**New Police Station**  
**Inuvik, NT**  
**Project Number: R.050563**  
**Addendum #1**  
**May 21, 2014**

Project Title:  
**NEW POLICE BUILDING  
INUVIK, NWT**

Sheet Title:  
**ADDENDUM #1  
DEMOLITION PHASING PLAN - 2/D1.0 - EXISTING SECURE BAY DEMOLITION PLAN**

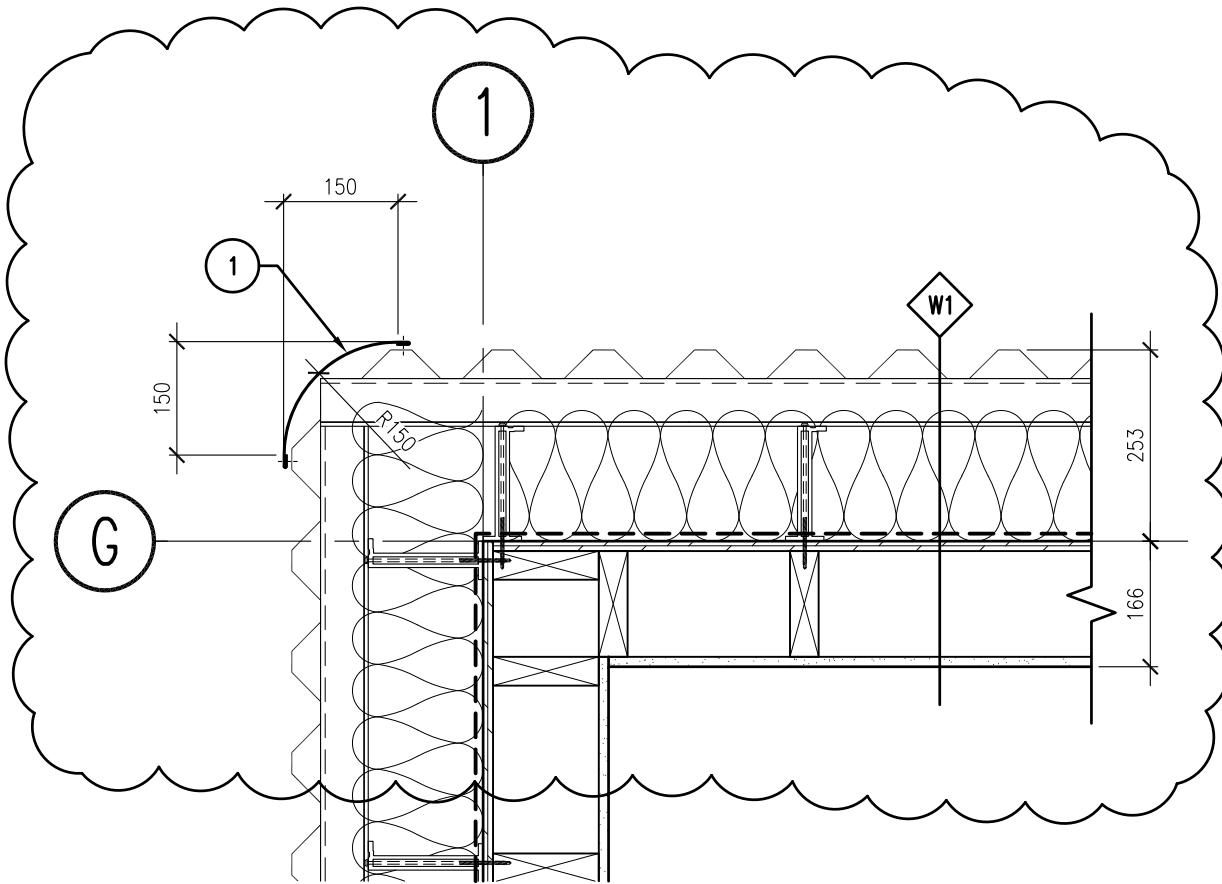
- .5 Revise Detail 2/D1.0 per appended Sketch Drawing ASK-01, prepared by IBI Group, dated April 15, 2014.

Sheet Title:  
**ADDENDUM #1  
CONSTRUCTION ASSEMBLIES - A0.3**

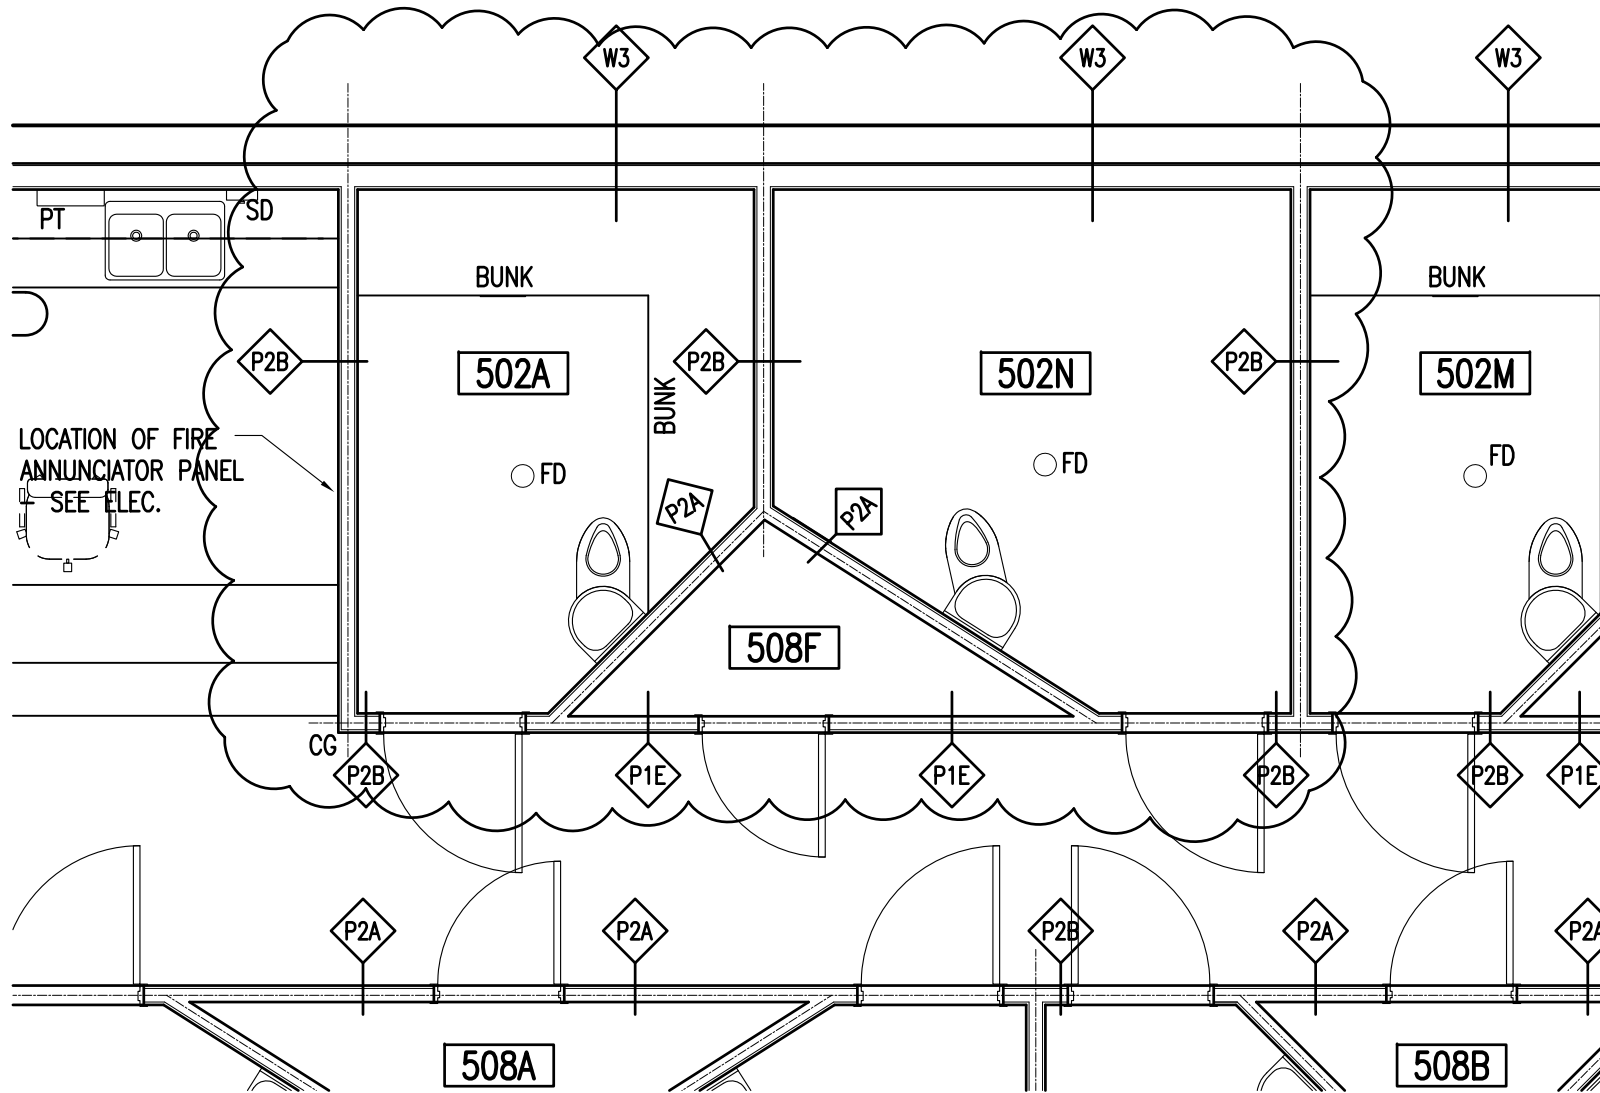
- 
- .2 Refer to Drawing A0.3 – Construction Assemblies, Symbol Legend, Code Synopsis, Issued For Tender; Dated March 17, 2014.
- .1 Revise parapet assembly PR1 and exterior wall assemblies W1, W2, W3, W3A, W4 and W7 as per appended Sketch Drawing ASK-04, prepared by IBI Group; dated April 15, 2014.

REVISED STEEL PIPE PILE SCHEDULE  
(REF. DWG S1.1)  
(ADD. S-01)

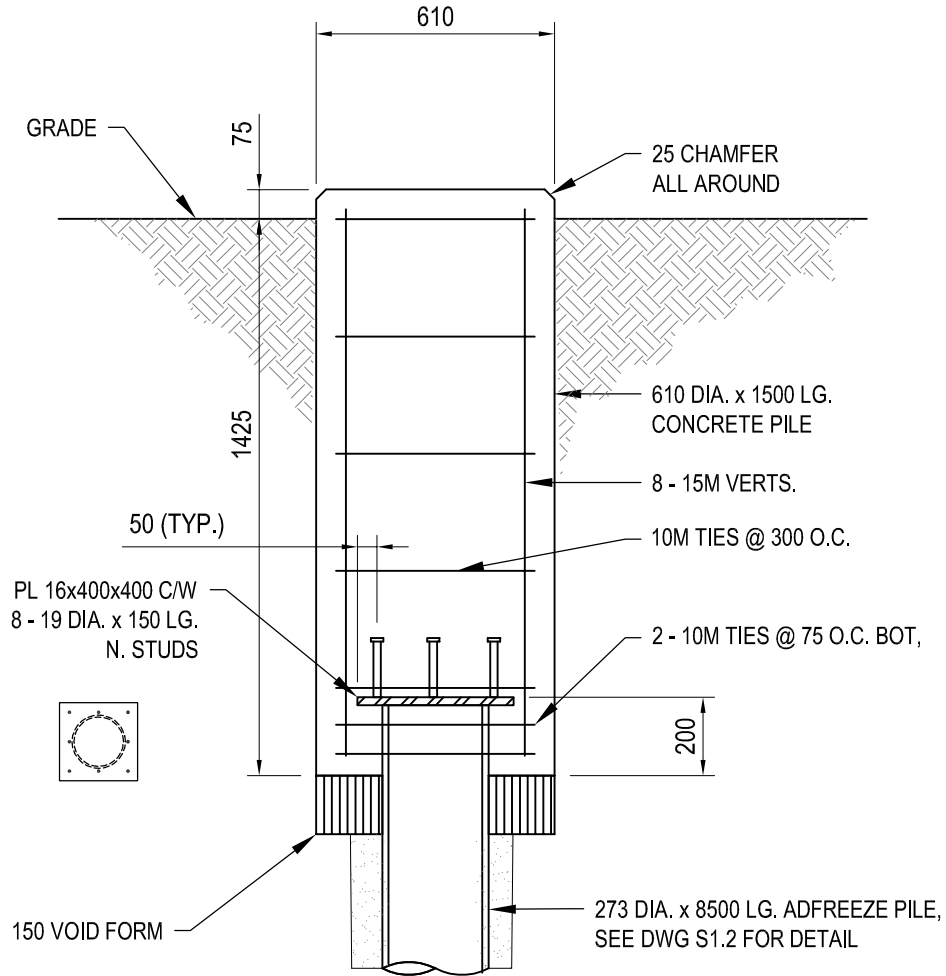
.1 The Steel Pile Schedule has been revised to show pile diameter and pile loads. Refer to attached sketch SSK-01.

REVISED SECTION "6"  
(REF. DWG S1.1)  
(ADD. S-01)

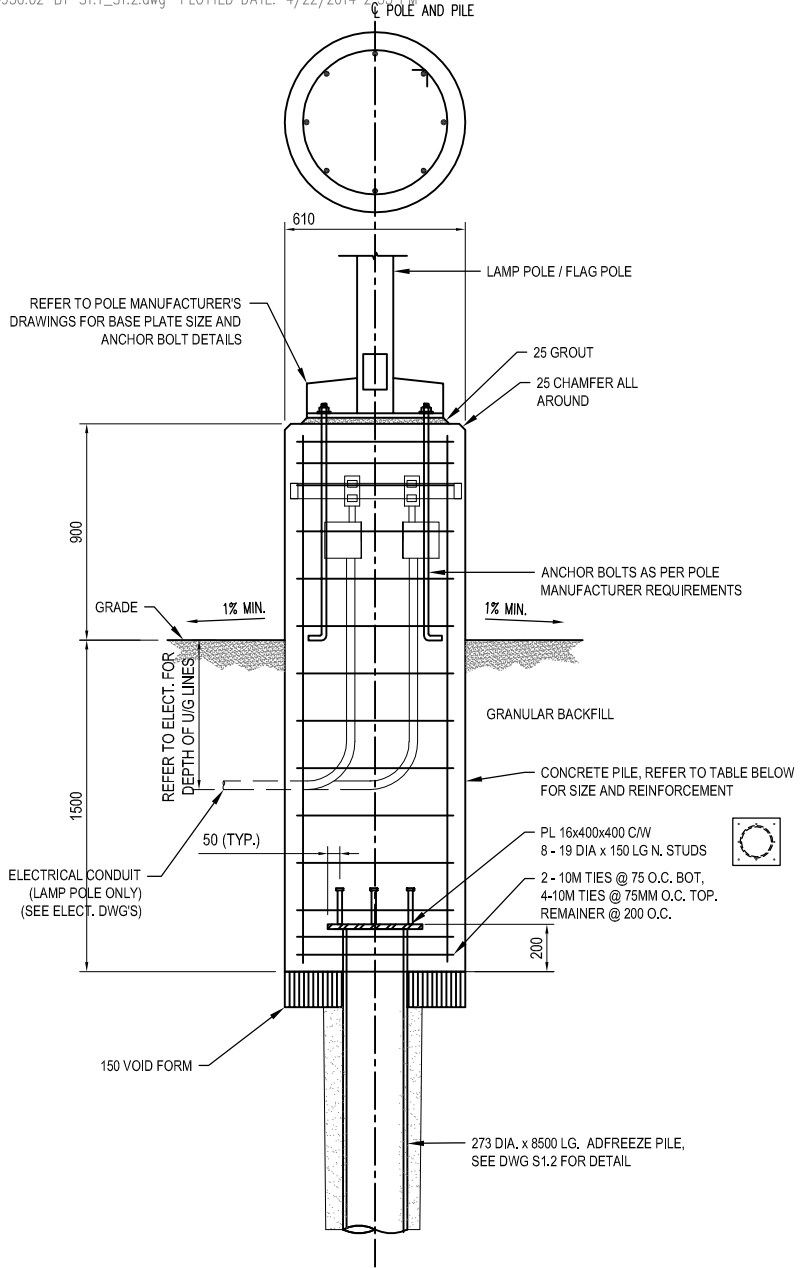
.2 Detail 6/S1.1 has been revised. Replace the 219 dia. thermopile with a 273 dia. x 8.5 m long Sch 40 Adfreeze steel pipe pile. Refer to attached sketch SSK-02.

TYPICAL ADFREEZE PILE  
 (REF. DWG S1.2)  
 (ADD. S-01)

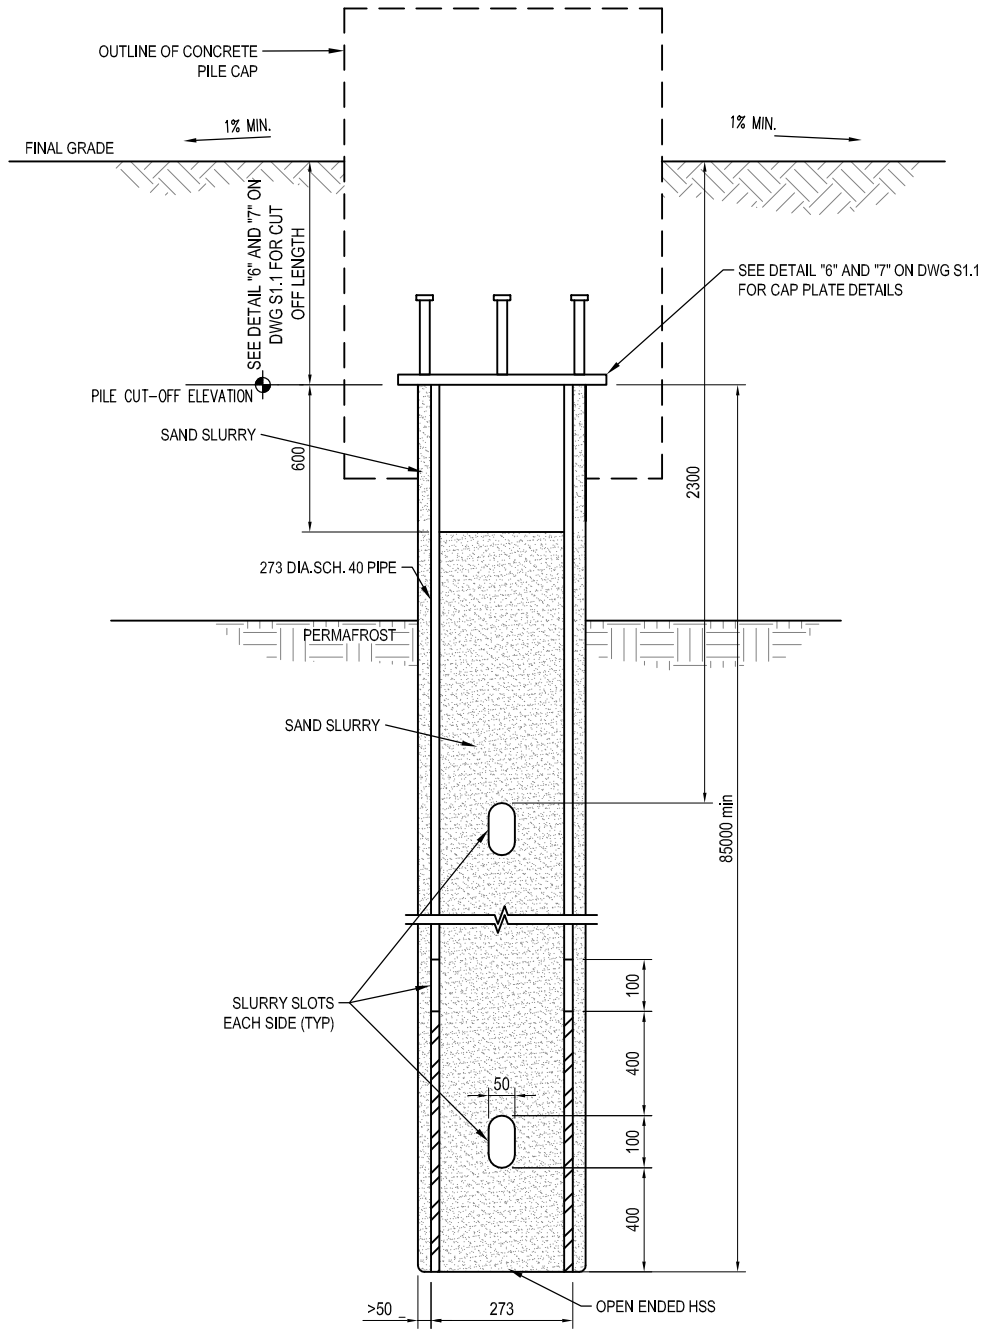
- .1 Detail 15A has been added to show the typical Adfreeze Steel Pipe Pile detail. Refer to attached sketch SSK-04.
- .2 Detail 16 has been revised. Rod sizes and hold down loads have been revised on the HD-2 and HD-3 details. Refer to attached sketch SSK-05.
- .3 Detail 17 has been revised to show pile bracing loads. Refer to attached sketch SSK-06.

REVISED PILE BRACING PLAN  
(REF. DWG S2.0)  
(ADD. S-01)

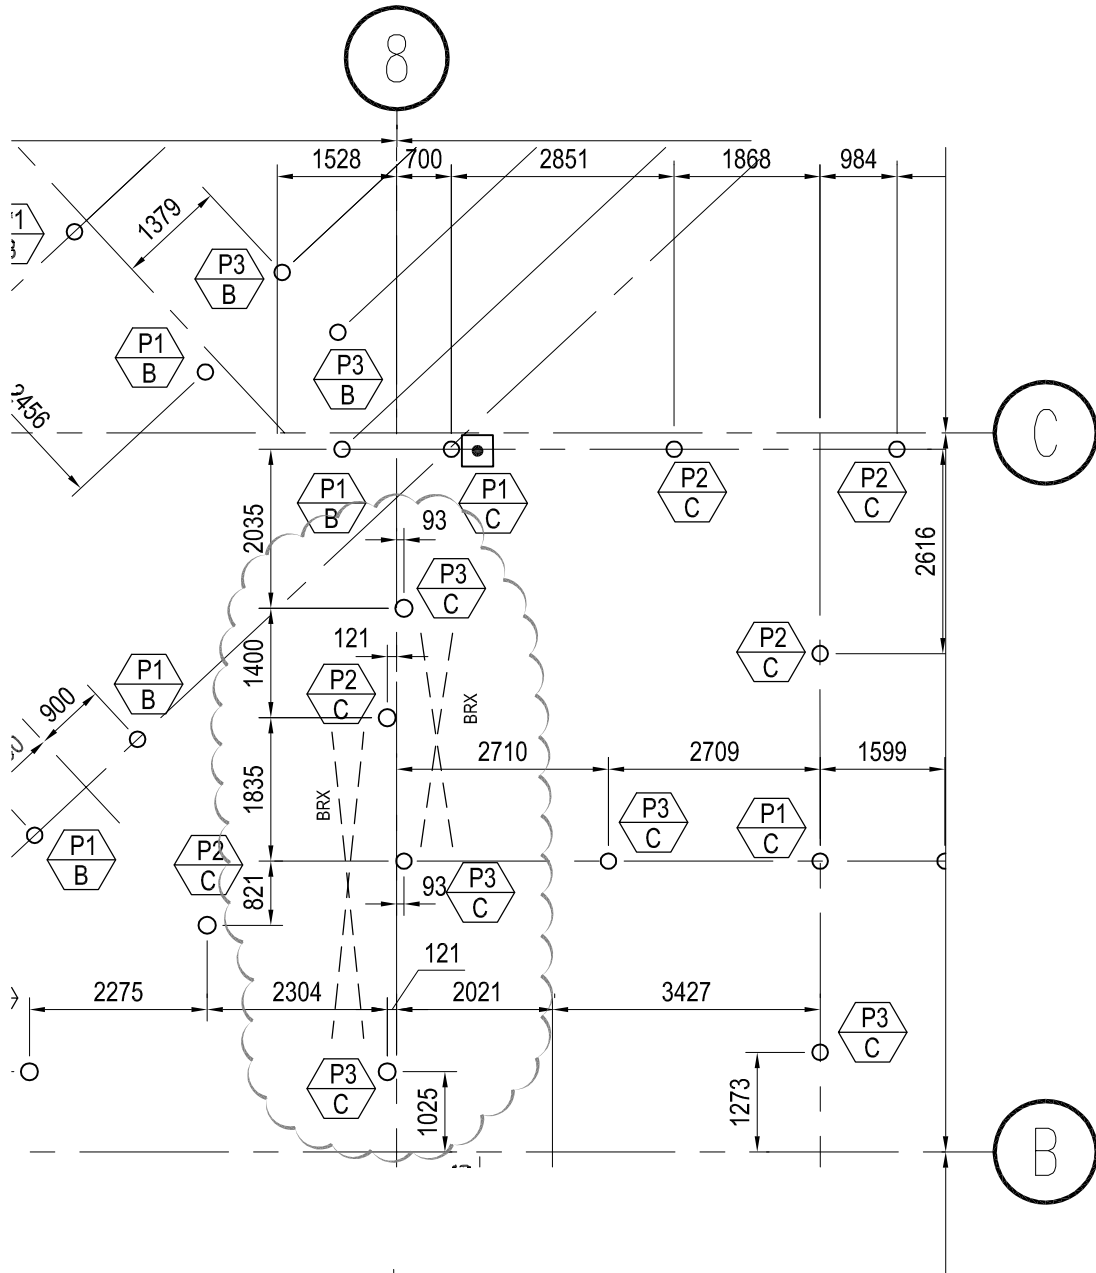
- .1 Refer to attached sketch SSK-07 for clarification of locations of pile bracing along Line 8.

REVISED SECTION "J"  
(REF. DWG S2.2)  
(ADD. S-01)

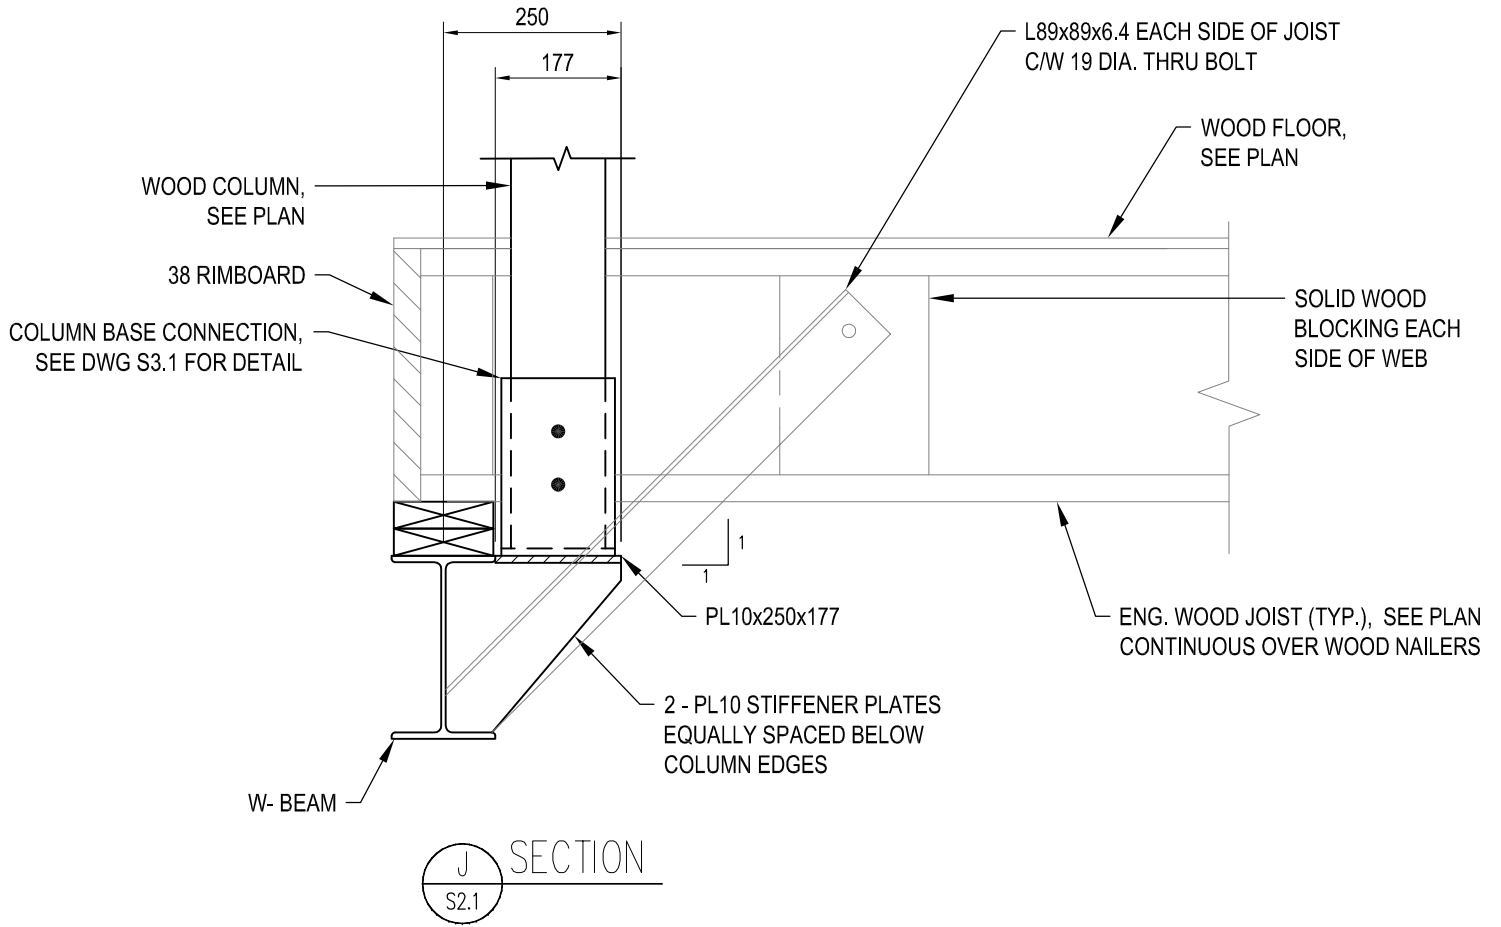
- .1 Section J/S2.2 has been revised. Refer to attached sketch SSK-08 for the revised section.

SECTION "P"  
(REF. DWG S2.3)  
(ADD. S-01)

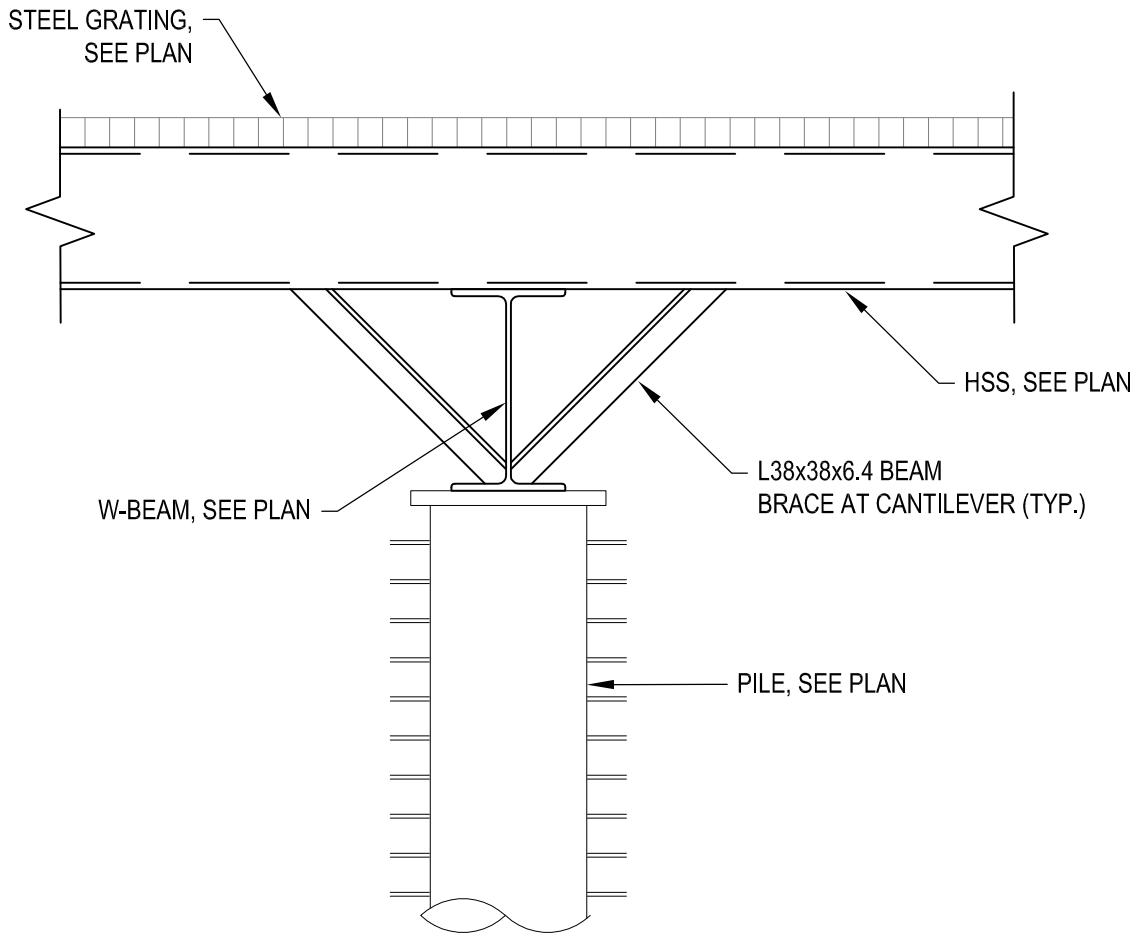
- .1 Section K/S2.1 has been revised to add Section P/S2.3 at the pile/ramp interface. Refer to attached sketch SSK-09.
- .2 Detail 3/S2.3 has been revised to read as Section P/S2.3 to show the L203x102 angle embedded in a concrete cap secured to the top of the gabion baskets. Refer to attached sketch SSK-10 for the revised section.
- .3 Detail 1/S2.3 has been revised to show the L203x102x13 angle embedded in a concrete cap secured to the top of the gabion baskets. Refer to attached sketch SSK-11 for the revised section.

REVISED SECTION "B"  
(REF. DWG S6.2)  
(ADD. S-01)

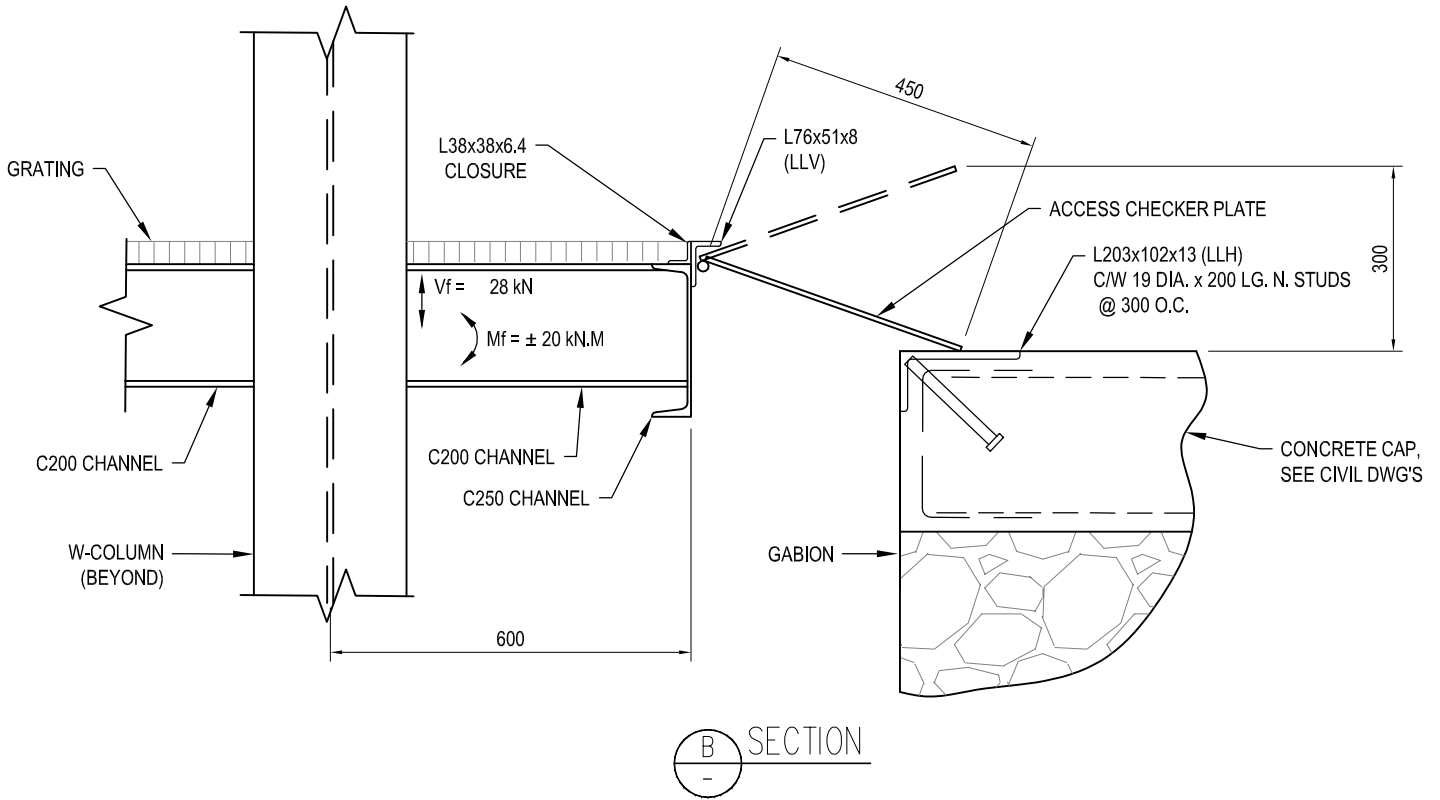
- .1 Section B/S6.2 has been revised to show the L203x102 angle embedded in a concrete cap secured to the top of the gabion baskets. Refer to attached sketch SSK-12 for the revised section.
